UNITED STATES PATENT AND TRADEMARK OFFICE

10/801,041

Office Action Summary

DETAILED ACTION

Exhibit "A"

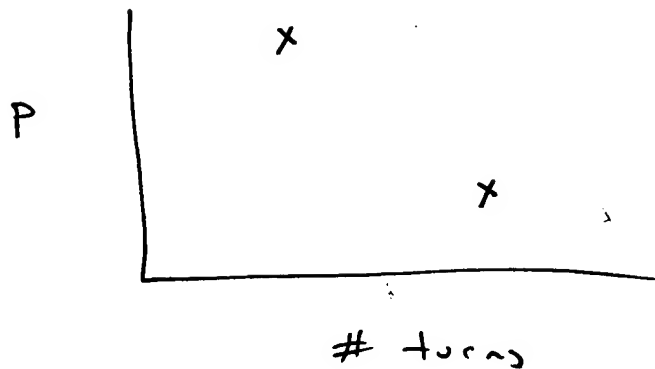
As to p. 5, regarding Claim 11; please look at Exhibit "A". While originally filed Para 17 provides for two points having different values (top graph), that does not mean that there is only an inversely proportional relationship (second graph from top). After all, the top graph may suggest a proportional relation (third graph from top), or something else (bottom graph). The top graph simply provides for two points, and therefore does not provide for the inversely relation now claimed.)

Applicant
has support
based on
para 17 for
two points \Rightarrow

claim 11 filed
11/12/05 calls for
inverse proportional
relation \Rightarrow
